HISTORIC LANDMARK COMMISSION STAFF REPORT

SK Hart Building
PLNHLC2008-00693 Porte Cochere and Circular
Driveway
630 East South Temple
January 7, 2008

Applicant: Richardson Design partnership, representing SK Hart Management.

COMPREHENSIVE SITE PLAN

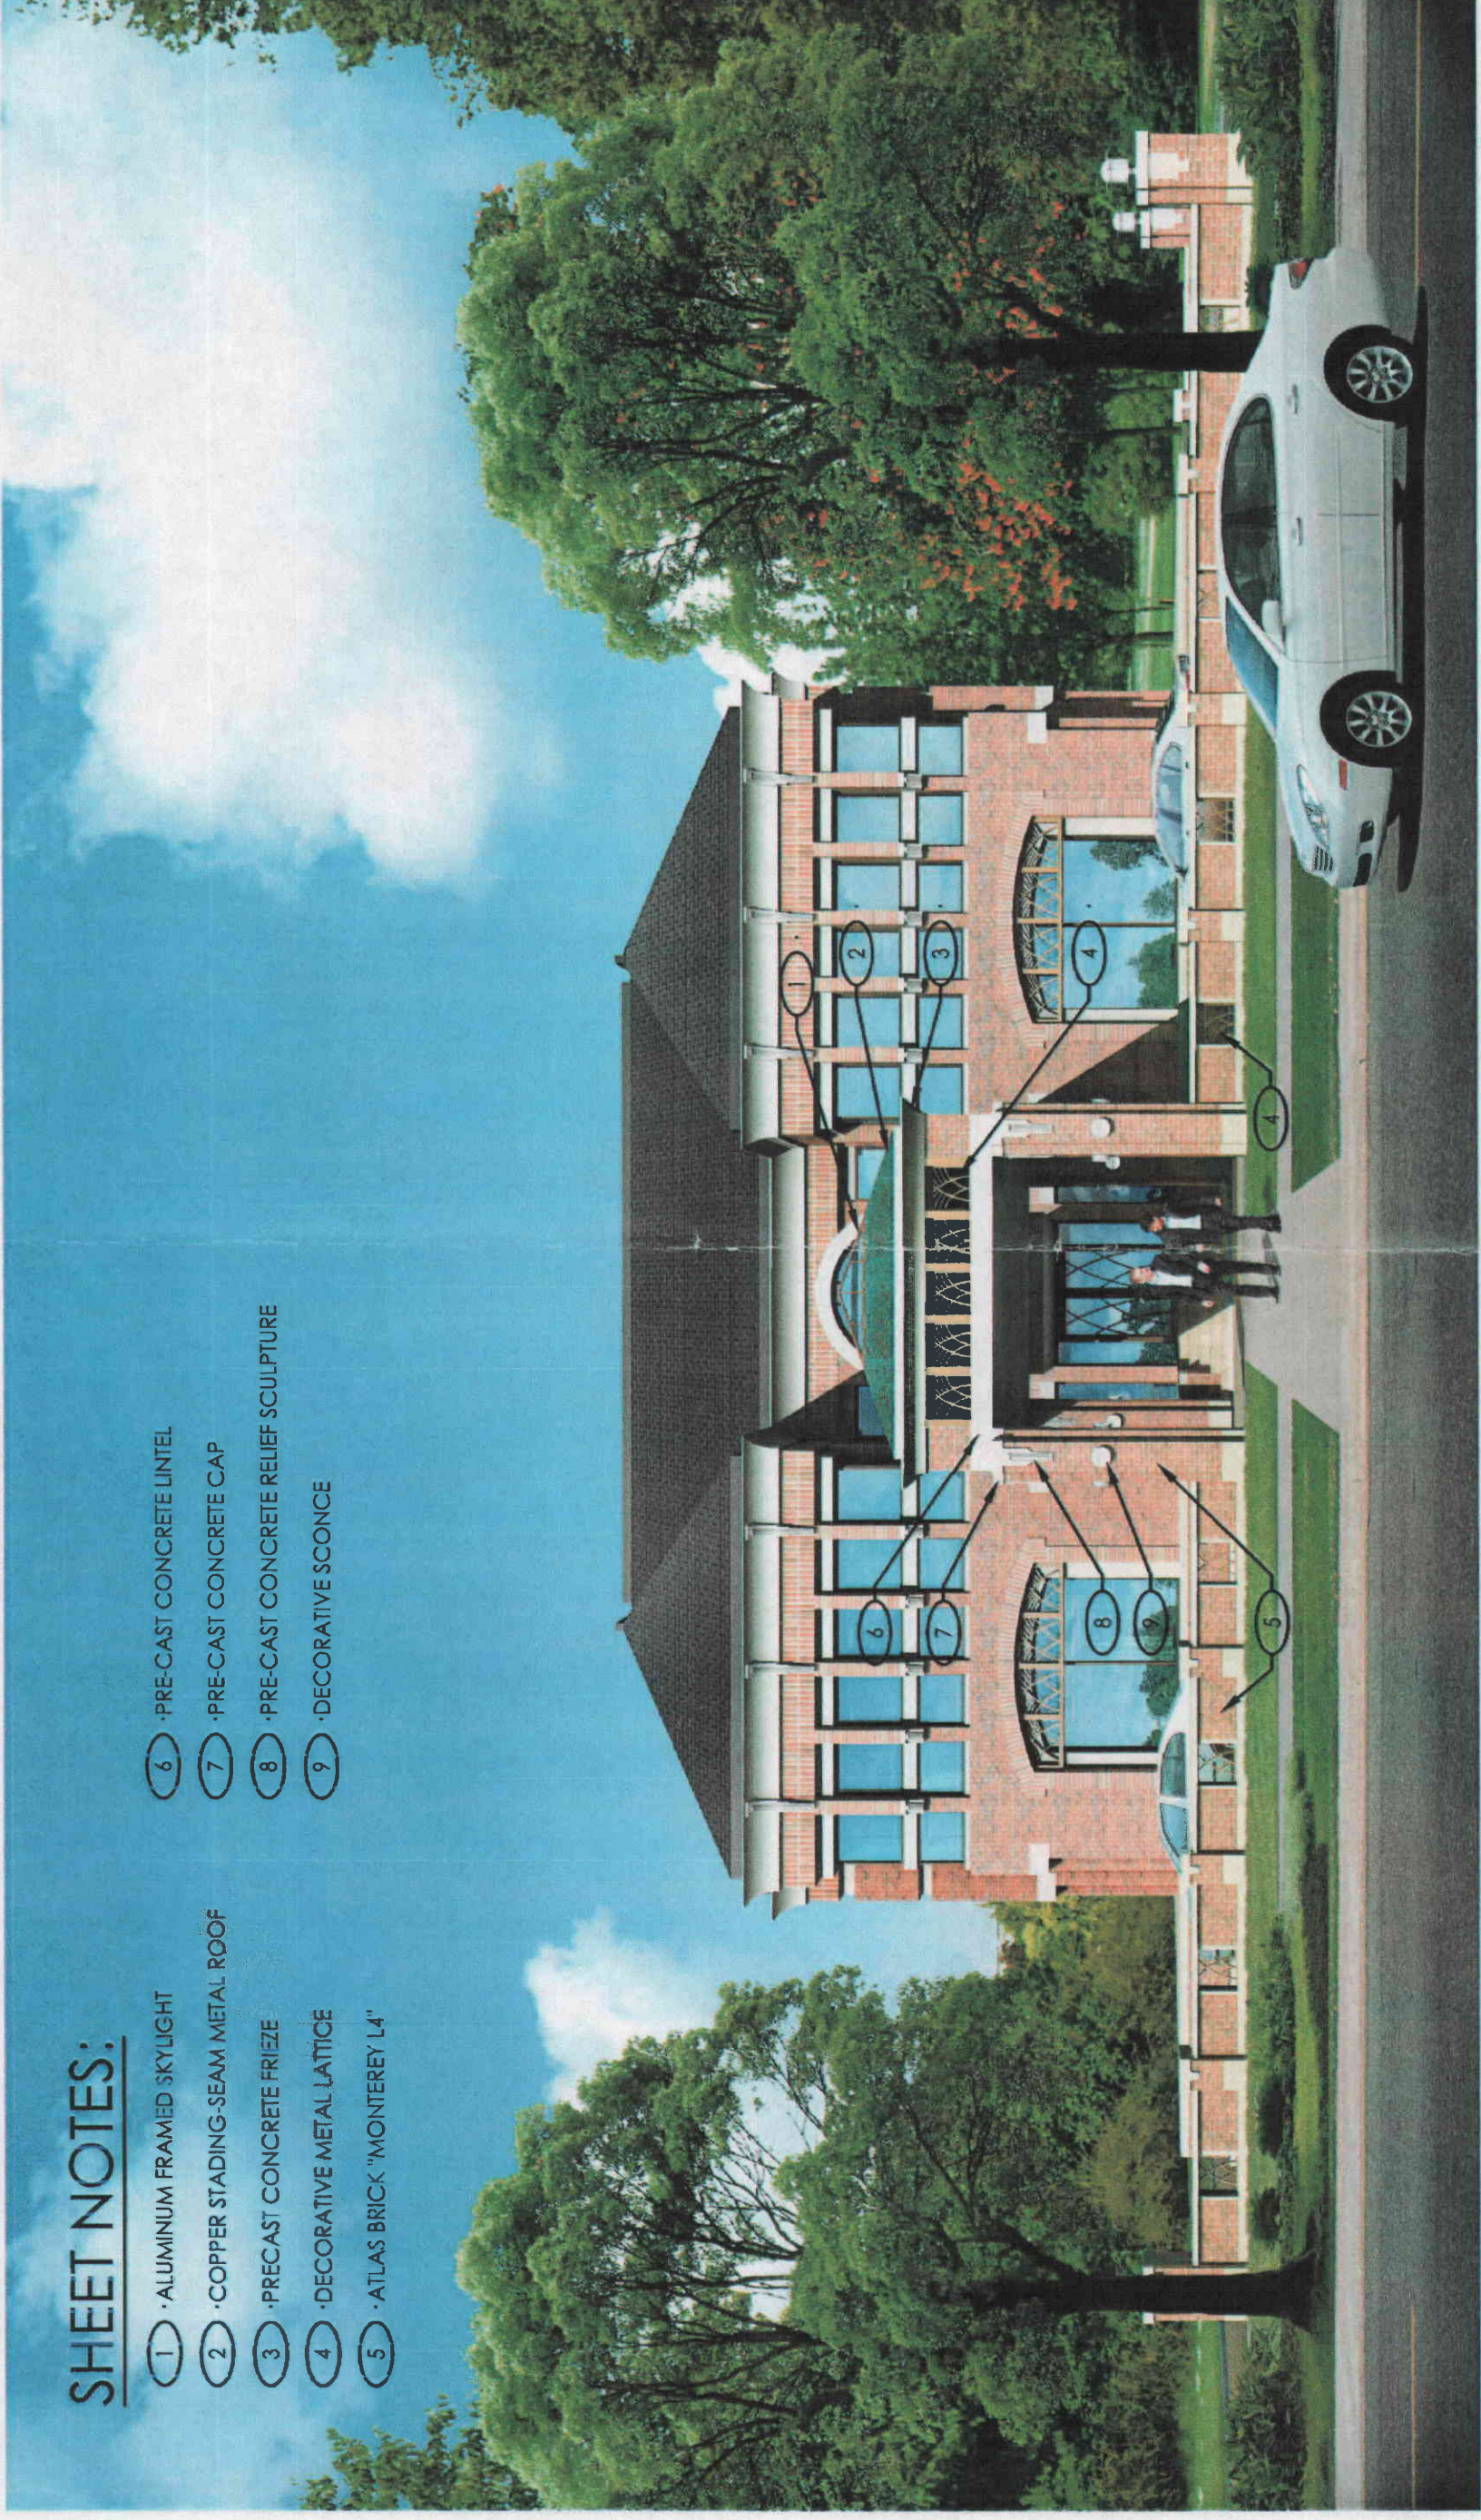
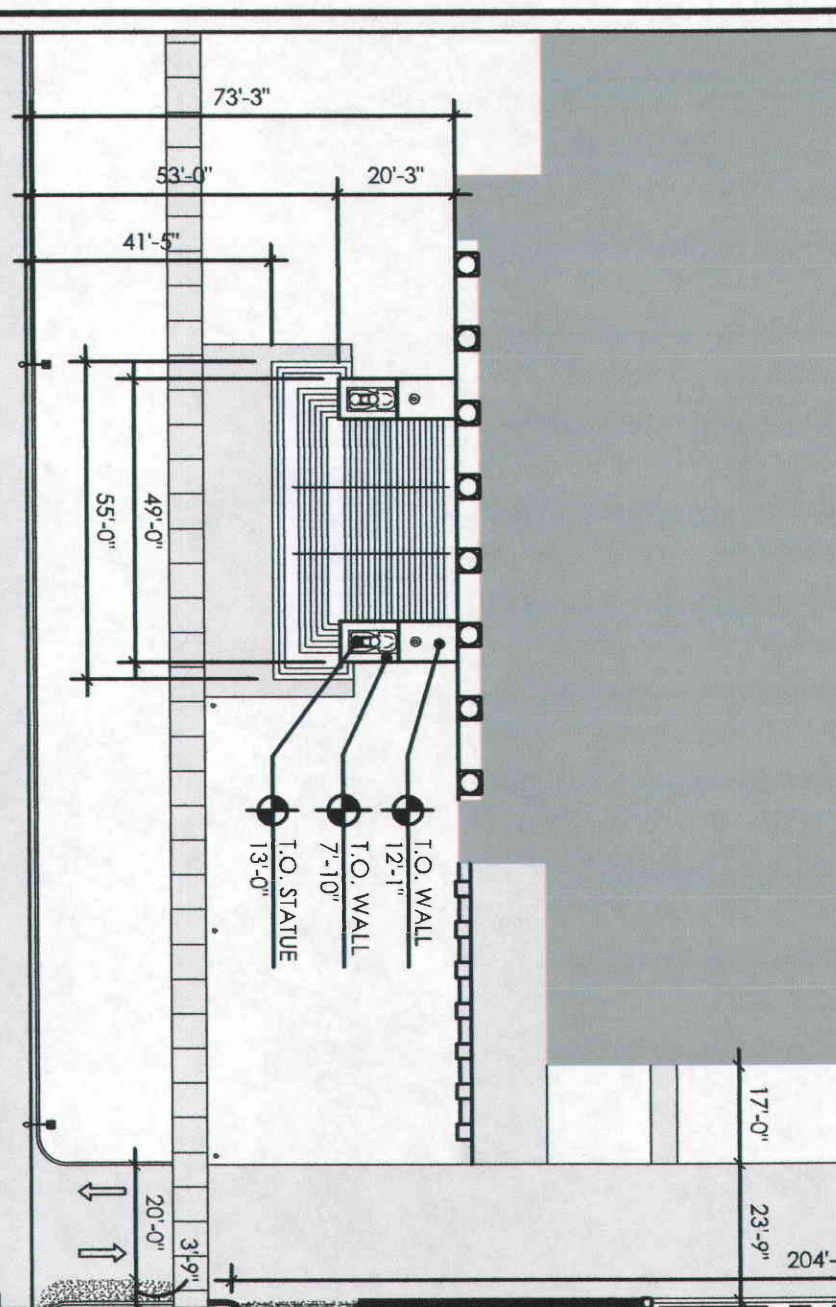
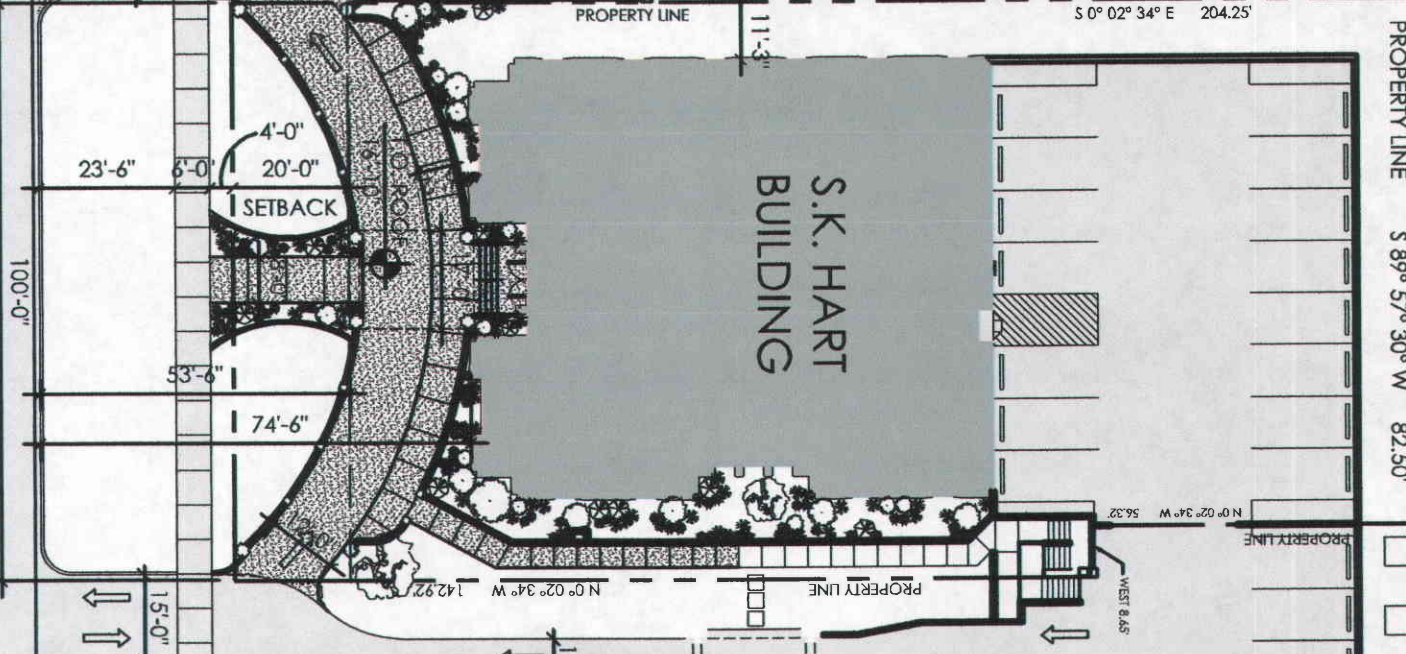
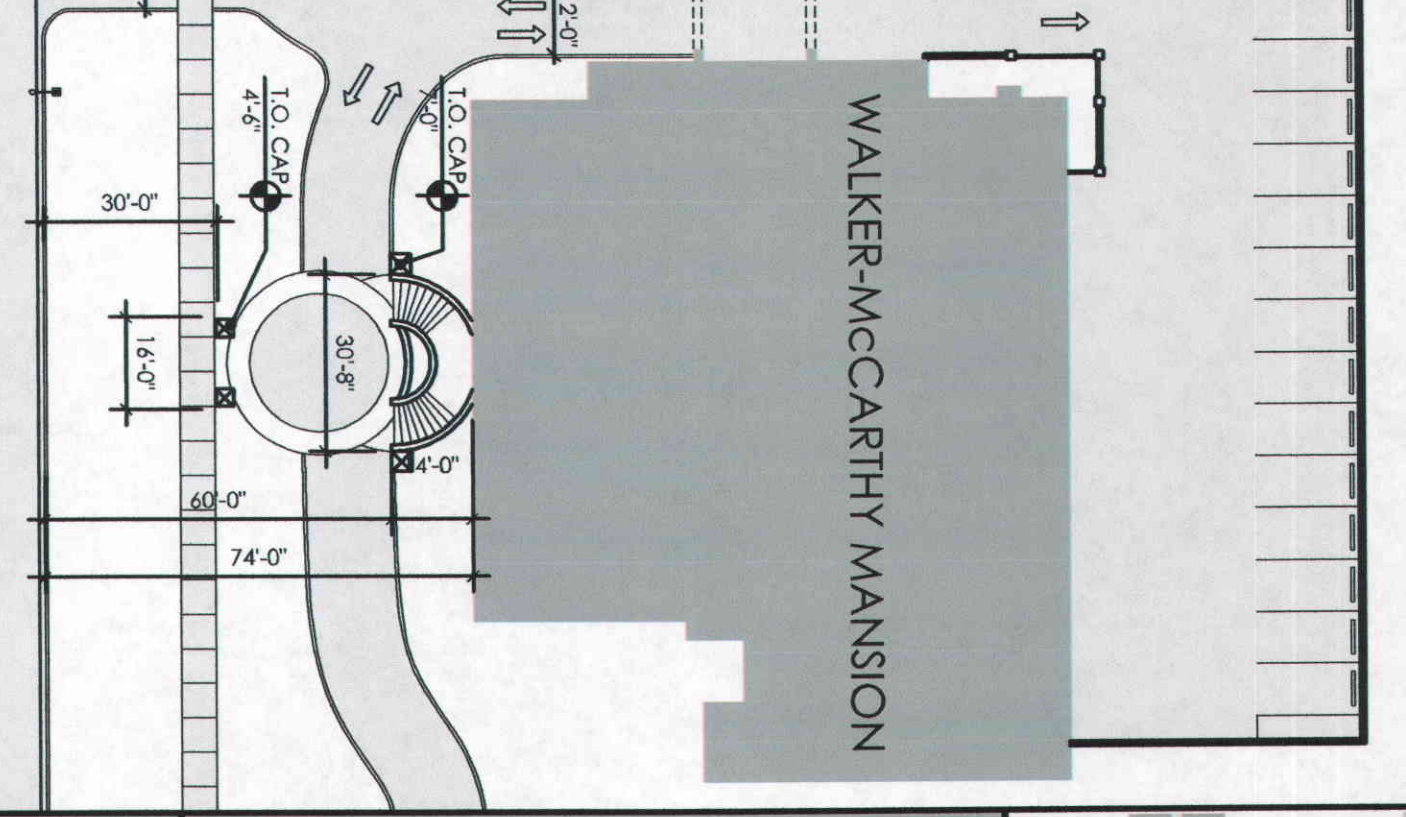
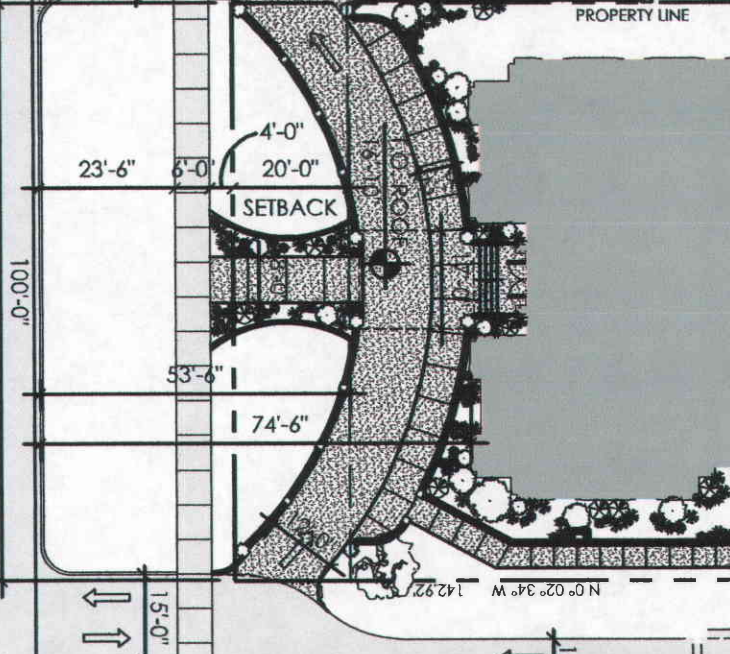
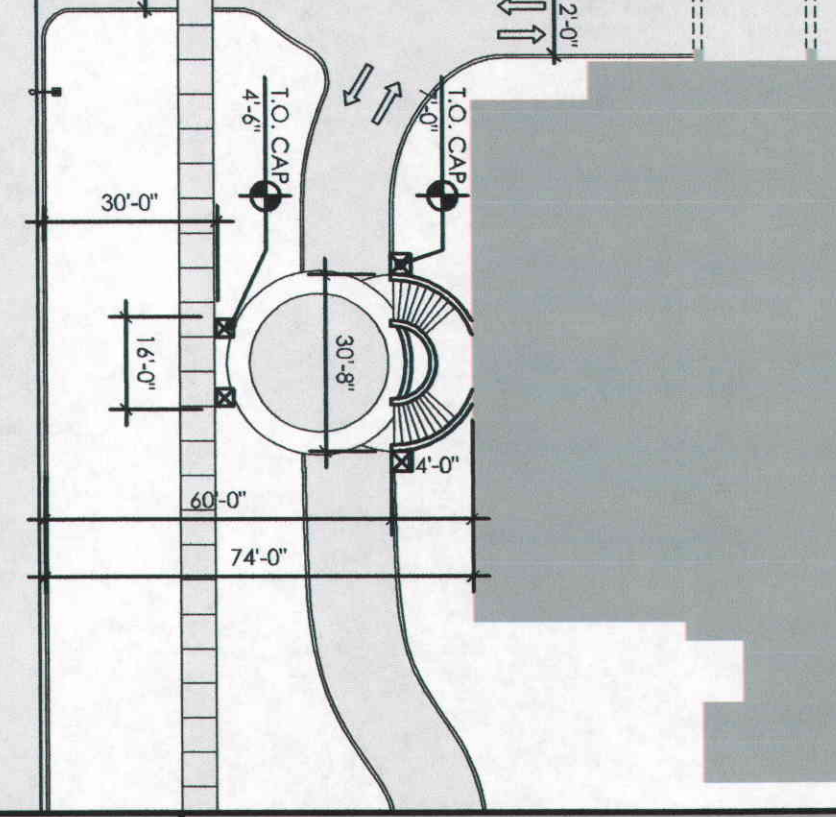
The proposed drive is in keeping with circular drive development requirements for minimum of 15' setback and 12' width.

Final geometric review approval is subject to grading information and height clearance of the Porte Cochere.

The access needs to have recorded cross easements with abutting properties at 650 East and 610 East South Temple. Past review the 1995 subdivision coordination between 630 E and 610 E for the parking structure access, may have wording or easements already recorded. Verification is required.

DISCUSSION: The porte-cochere extends closer to the street than other structures on the block face. This alters the relationship of the subject building to the street in a manner that is not consistent with the historic development pattern on the block face. The circular driveway and wall in front of the porte-cochere are similar to the drive on the property to the west and, on its own, does not negatively alter the relationship of the building to the street. The proposed circular driveway would require the removal of a portion of the historic fence along the east property line. The materials of this fence match the materials on the Masonic Temple. The fence creates a visual separation between the Masonic Temple and the subject property, which is a noncontributing structure. Removing the fence alters the historic relationship between the two properties.

FINDING: The proposed porte-cochere alters the spaces between the subject property and the adjacent properties and result in the removal of a historic fence. The proposal does not comply with this standard.
